County of Bernalillo
State of New Mexico
Public Works Division

Subject: Bernalillo County Regional Recreation Complex (BCRRC), Mesa del Sol Traffic Impact Study

Below are Bernalillo County comments on the subject draft TIS dated April 18, 2022. Please address these comments for the subsequent submittal.

INTERSECTION 2 – ACCESS 2 & UNIVERSITY BLVD.

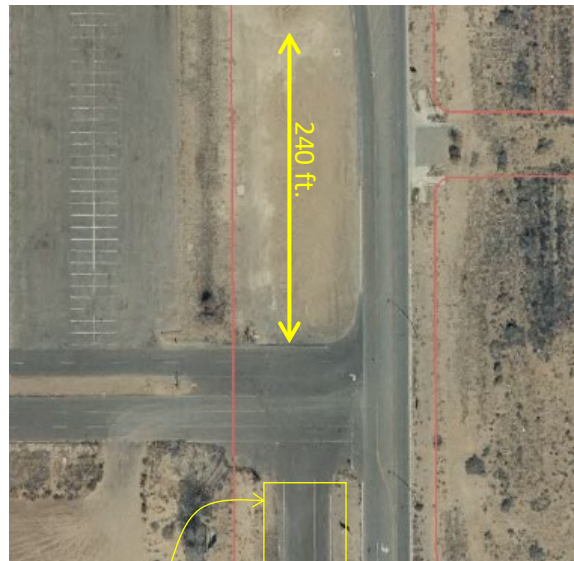
- a. There appears to be sufficient ROW for SB right-turn lane. This improvement needs to be required with substantial completion of the BCRRC or with full build out of University Blvd as part of the Mesa del Sol Level B Master plan, whichever comes first.

- b. The 2026 analysis provides a NB left lane. At this intersection the TWLTL converts to a SB left. There is no NB left lane. Although there is not many NBL turns, the analysis should accurately depict current conditions.

- c. The 2036 Mitigated analysis also provides a NBL. This center median area currently serves SBL to Fritts Crossing. This area cannot be a TWLTL due to conflicting lefts. Address which left turns the center turn lane will accommodate.

- d. EBL Configuration: There is a second EBL that cannot be used. Should it go away?
 - e. There are two receiving lanes into the site. Should they both be included?

- f. The Bobby Foster frontage road that runs parallel to University Blvd will be closed further south.
- There should be some form of closure to keep motorists from making EBR turns at this location when the Montage Units improvements go to construction.

This two-way access road will no longer be available with the Montage Units offsite improvements
